SERVICE BULLETIN

Fuel Suction Tube

Up to Serial Number 250115 (January, 2005)

Figure 1. Suction Tube

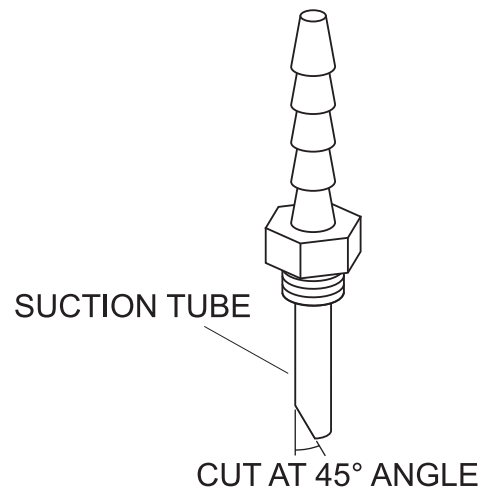
The Nissan engine will not stay running. This may cause fuel pump to overheat.

It was discovered that during hot weather, the poly fuel tank will slightly warp causing the tank bottom to touch the fuel suction tube. This restricts the fuel flow to the pump thus starving the engine.

1. Disconnect the fuel hose from the barb fitting located on the fuel suction tube.
2. Using a 9/16-inch deep socket, remove the suction tube from the tank.
3. Modify the tube by cutting a 45° angle cut. See Figure 1.
4. Make sure that the angle cut is not left sharp. A sharp cut will eventually wear a hole in the tank.
5. Place the modified suction tube back into the fuel tank and reconnect the fuel hose to the barb fitting.
